**Advanced Passive 1000 (AP1000)
Generic Technical Specification Traveler (GTST)**

Title: Changes Related to LCO 3.7.6, Main Control Room Emergency Habitability System (VES)

Figure B 3.7.6-12 (page 1 of 1)
Compressed Air Storage Tanks Minimum Volume – One Bank of VES Air Tanks (8 Tanks)
Inoperable

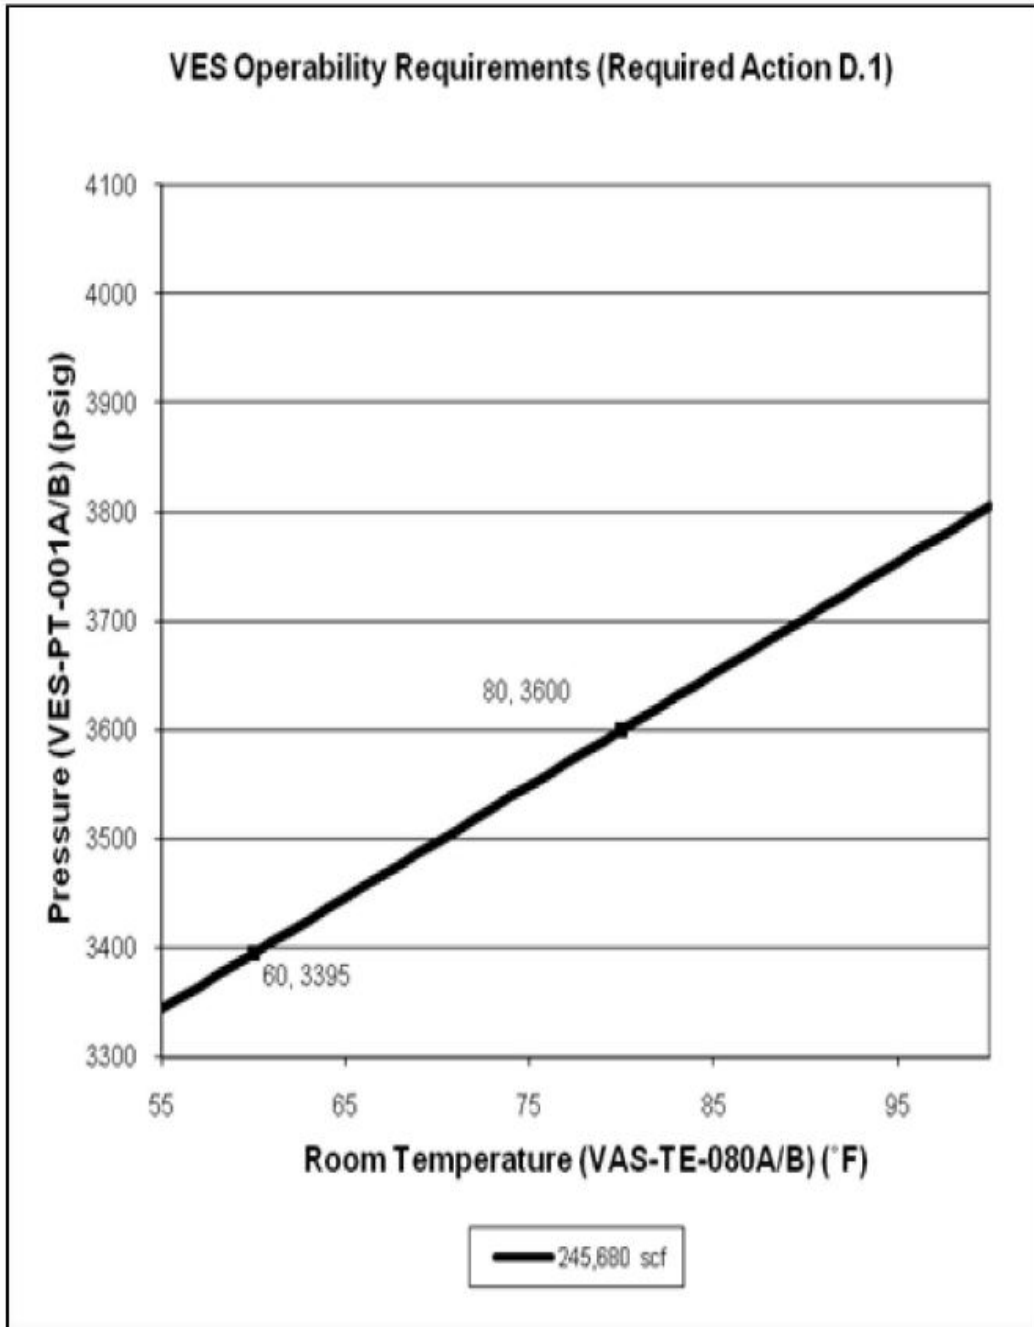
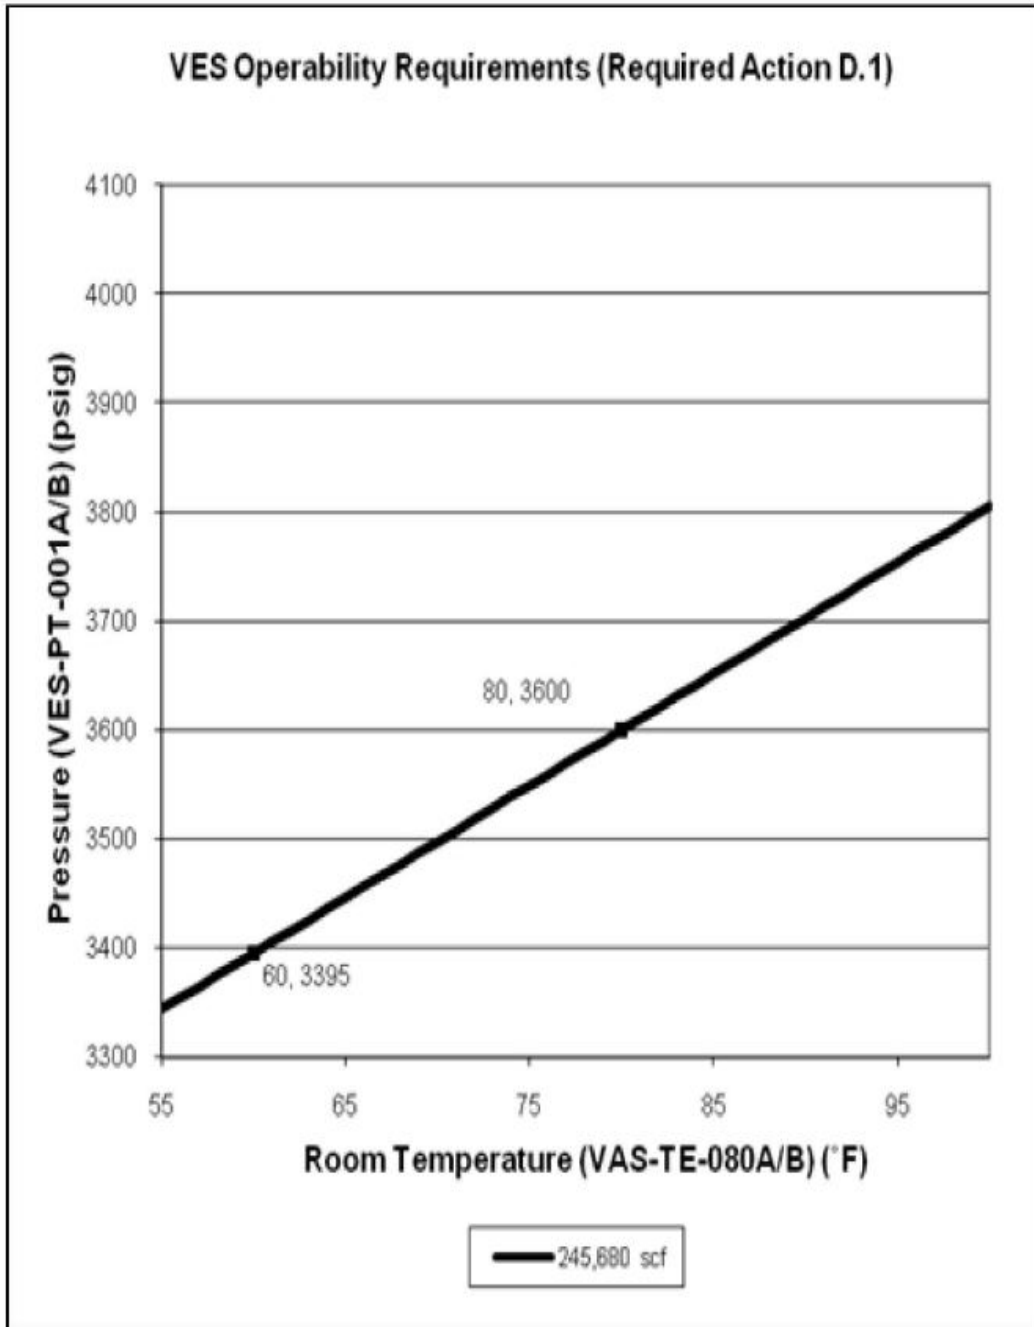
. . . The standard volume is determined using the compressed air storage tank room temperature (VAS-TE-080A/B), compressed air storage tanks pressure (VES-PT-001A/B), and Figure B 3.7.6-~~12~~, Compressed Air Storage Tanks Minimum Volume - One Bank of VES Air Tanks (8 Tanks) Inoperable. . . .

Figure B 3.7.6-2 is updated and renumbered as Figure B 3.7.6-1, and Figure B 3.7.6-2 is updated and renumbered as Figure B 3.7.6-1. (APOG Comment)

13. (Internal # 422 and 423) Revise TS Bases Figures B 3.7.6-1 and B 3.7.6-2 to add “Acceptable” region labels. The order of the Figures is swapped to align with Writer’s Guide convention. This is resolved by making the recommended change.
14. (Internal #1) Include TSTF-522 in the reference disposition tables, as “TSTF already included in GTS Rev. 19 with variation.” Note that minor changes to the Bases are as appropriate to the AP1000 design.

In addition, renumber Figure B 3.7.6-2 as Figure B 3.7.6-1, and Figure B 3.7.6-2 as Figure B 3.7.6-1. This non-technical change provides improved clarity, consistency, and operator usability. This is resolved by making the recommended change.

Figure B 3.7.6-24 (page 1 of 1)
Compressed Air Storage Tanks Minimum Volume

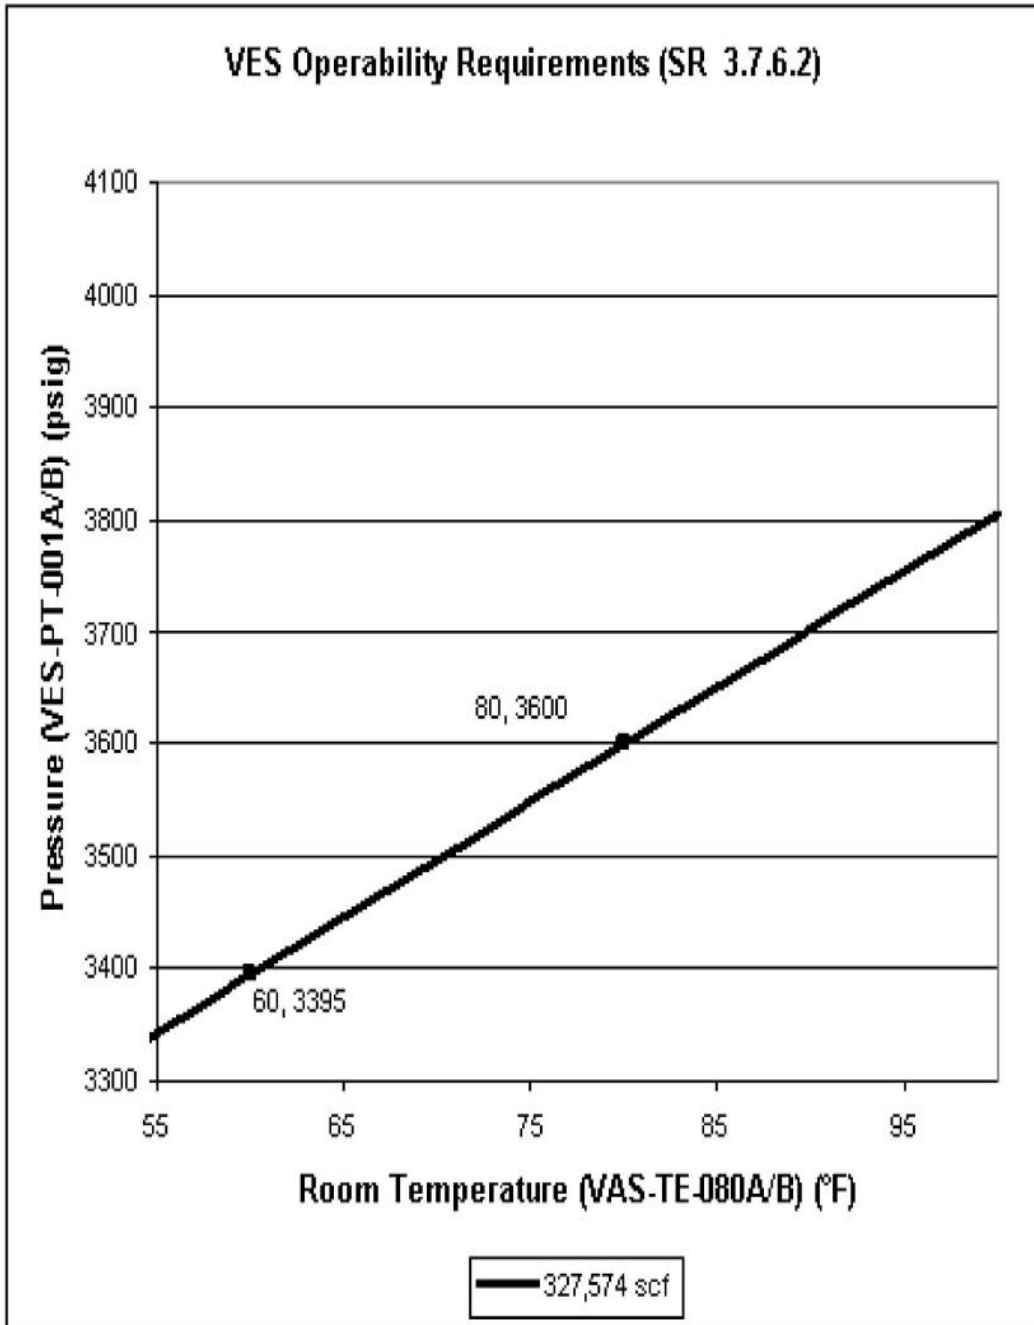
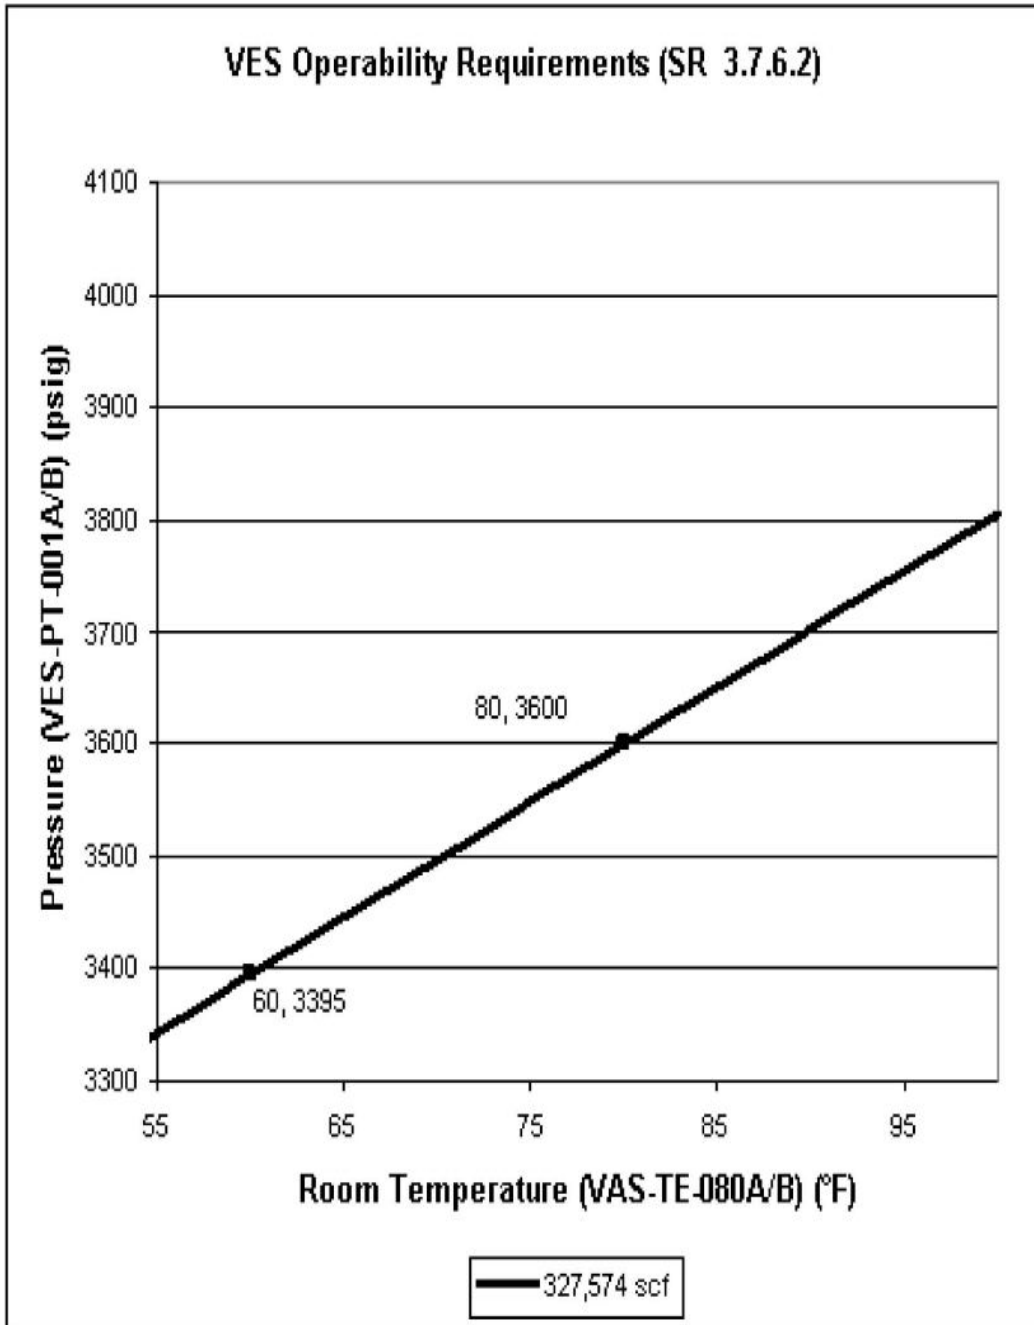
The standard volume is determined using the compressed air storage tank room temperature (VAS-TE-080A/B), compressed air storage tanks pressure (VES PT 001A/B), and Figure B 3.7.6-~~24~~, Compressed Air Storage Tanks Minimum Volume. . . .

This non-technical change provides improved clarity, consistency, and operator usability. This is resolved by making the recommended change.
